MEMO

Re: Narrow Passage, Amendment to a Conditional Planning Area – Staff Analysis

Conditional Use Rezoning Plan For Narrow Passage Subdivision (64.2 % Open Space)

NARROW PASSAGE – APPROVED CONCEPT PLAN GREENWAY OPTIONS (A, B, & C)

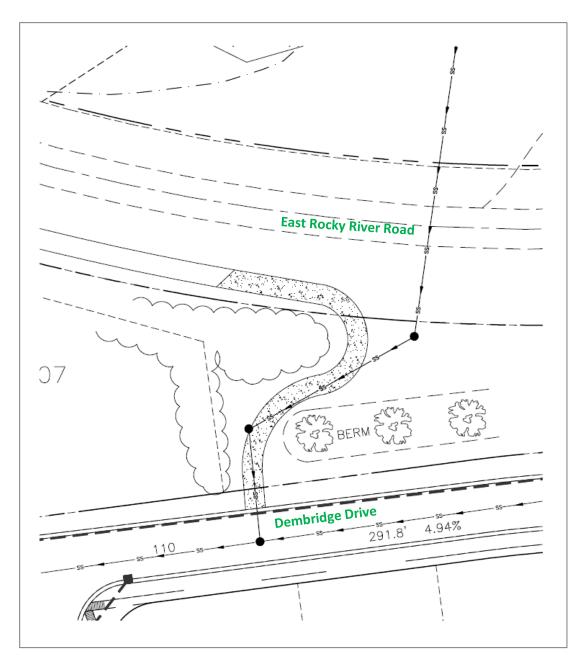
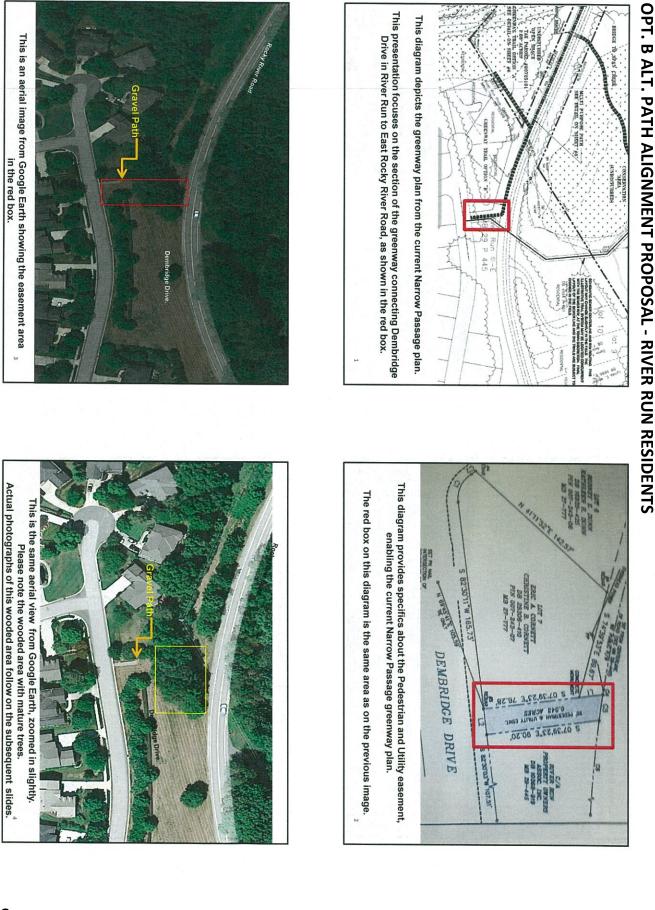
Additionally, since the July 2016 Board of Commissioners meeting several residents have voiced concern about the proposed "Option B" greenway connection required by the approved 2015 Narrow Passage Conditional Master Plan. This connection would extend the required greenway from East Rocky River Rd. directly to Dembridge Dr. The necessary easement for this path – through which the proposed sewer extension would also run – has already been granted by the River Run Property Owner's Association; however, River Run residents have proposed an alternative alignment. Citing the loss of trees and increased exposure to the noise of East Rocky River Road as their primary objections to the existing alignment, residents have identified a conceptual route that jogs the path east about 100' around an existing stand of trees and connects to East Rocky River Road. This alignment mitigates the residents' concerns by saving the tree stand and preserving the existing buffer between East Rocky River Road. The Davidson Parks & Rec. Dept. and CLT Water have agreed to the alternative conceptual alignment assuming that all necessary technical criteria are met (i.e. ADA requirements, design standards, etc.). The residents' have met with the project team on multiple occasions and the project team has indicated a willingness to find a solution via the alternative alignment that works for the residents, project team, and Town.

g. Greenway (Southern Parcel): The Developer shall satisfy the greenway obligation on the southern parcel (PID #00725101) and adjacent parcels by connecting the path along East Rocky River Rd. to Dembridge Dr. via an easement that retains the existing tree stand along East Rocky River Rd. and connects to Dembridge Dr. at the existing gravel path/berm entrance adjacent to PID 00724307. See Exhibit "NP Handout - Greenway Options & Area Sewer Context."

The proposal entails a request to modify the approved conditions such that municipal sewer may be allowed to serve the project site. Staff supports this goal and believes that modifying the condition language to allow this opportunity is a reasonable request. Staff affirms the initial recommendation provided on 7/12/16 regarding project density, layout, and open space requirements, adding that any alignment should conform to CLT Water policy and with the understanding that the developer will participate as agreed with CLT Water to develop/support the expansion of the West Branch line. Additionally, staff recommends the proposed Option B greenway alignment that preserves the existing tree stand.
